### W411 – Replacement of Transfer Gearbox

The following information pertains to a voluntary Customer Recall Campaign/Workshop Service Action involving a certain range of model year 2004 Cayenne (V6), Cayenne S and Cayenne Turbo vehicles.

**Concerns:**      **Workshop campaign W411 – Checking cast batch number on the housing of the transfer gearbox and replacing transfer gearbox if necessary**

Figure 1

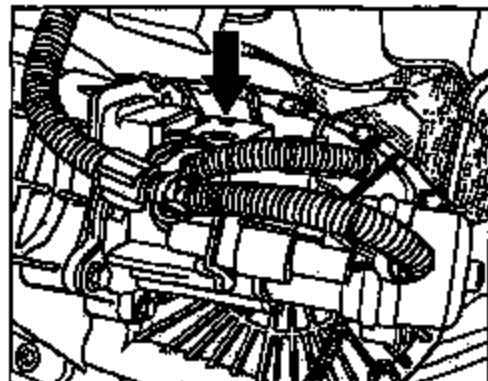
1. Raise vehicle on lifting platform.
2. Check the batch number cast into the transmission housing on the transfer gearbox. The cast batch number is located behind the transfer gearbox servo motor in the third marked field seen from the right (see arrow, Figure 1).

Figure 2

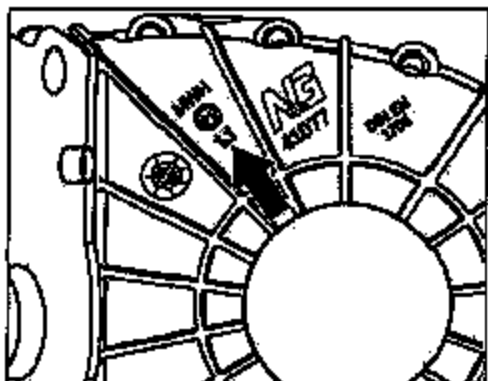
- 2.1 Cast batch number "1.1 or 5.5" (Figure 2, arrow) transfer gearbox Ok – continue with Step 4. (shown with transfer gearbox servo motor removed)

Figure 3

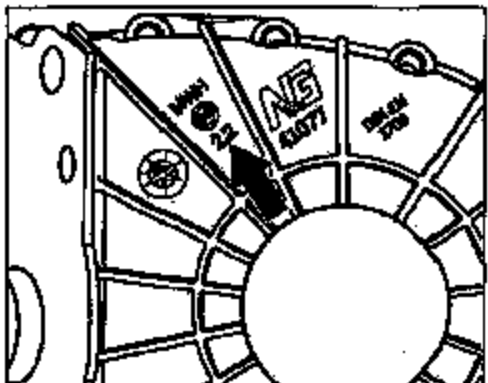
- 2.2 Cast batch number "2.2" (Figure 3, arrow) transfer gearbox not Ok – continue with Step 3. (shown with transfer gearbox servo motor removed)

3. Remove transfer gearbox according to Technical Manual, Group 3, Chapter 39 65 19 and install new transfer gearbox.
